PIC16F627A/628A/648A

PIC16F627A/628A/648A Rev. A Silicon/Data Sheet Errata

The PIC16F627A/628A/648A parts you have received conform functionally to the Device Data Sheet (DS40044F), except for the anomalies described below.

FIGURE 1: BLOCK DIAGRAM OF RBI, RB2

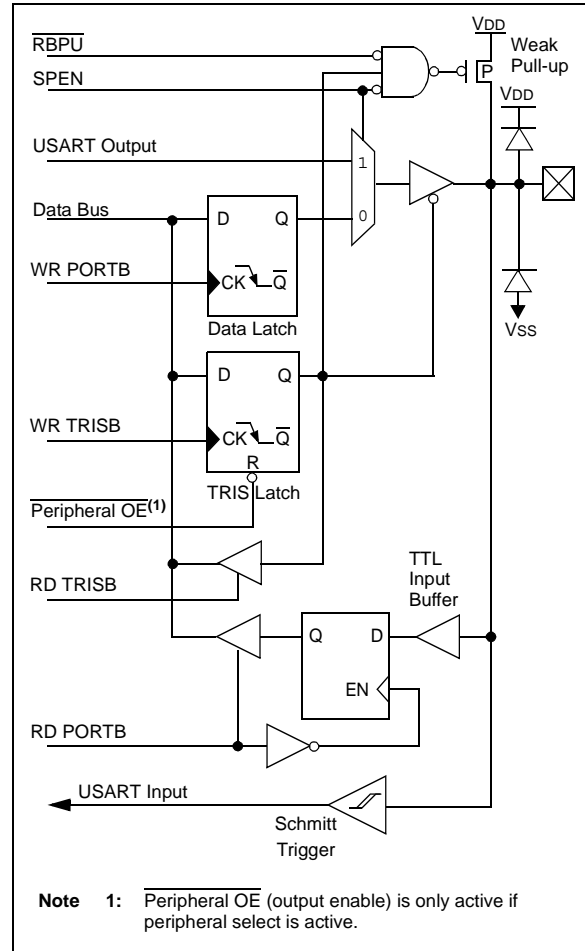
1. USART control of the RB1/RX/DT and RB2/TX/CK differs from the data sheet. Figure 5-9 and Figure 5-10 indicate that the USART circuit overrides the output drivers via the Peripheral OE signal. In fact, the Peripheral OE signal forces the TRISB<2:1> to an output (Reset) state (see Figure 1). Subsequently, the TRISB<2:1> must be set or configured to receive data.

In Asynchronous mode, when transmit is enabled (TXEN = 1 and SPEN = 1), the TRISB<2> latch is cleared to '0' by the USART peripheral circuitry. When disabling transmit (TXEN = 0), the TRISB<2> bit should be set to '1' to configure the RB2/TX/CK pin as an input.

In Synchronous mode, when changing from transmit to receive, clear the TXEN bit first, then set TRISB<1> to '1' to configure the RB1/RX/DT pin as an input before setting SREN or CREN to receive.

When disabling the USART (SPEN = 0), TRIS<2:1> should be reconfigured for input or output as required by the application.

FIGURE 14-18: TYPICAL IN-CIRCUIT SERIAL PROGRAMMING™ CONNECTION

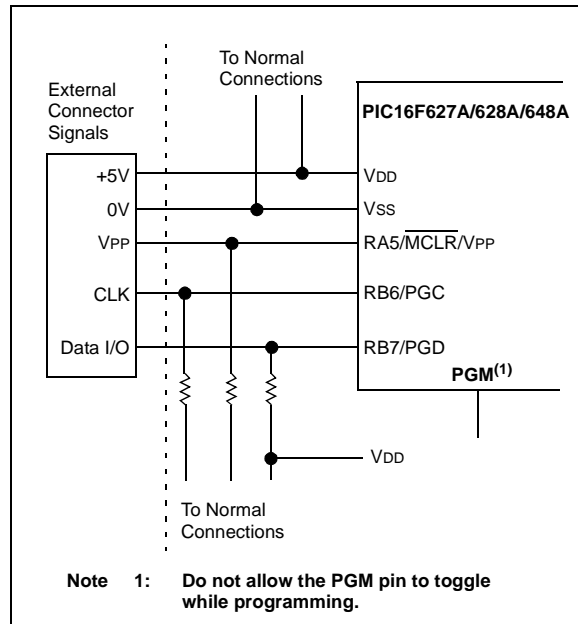
Section 14.11: In-Circuit Serial Programming and Figure 14-18: Typical In-Circuit Serial Programming Connection. The following paragraph and Note box are being added to the end of Section 14.11 and Figure 14-18 is updated to include PGM, noted in bold.

If LVP is not being used for programming, but the LVP Configuration bit is set (or LVP feature is enabled), the PGM pin must not be allowed to toggle while programming. The PGM pin is edge sensitive and if an edge is detected during programming, it may cause the PC to reset. If the LVP feature is disabled, the PGM pin will have no effect on programming.

Note: The LVP feature is enabled by default when the LVP Configuration bit is set.
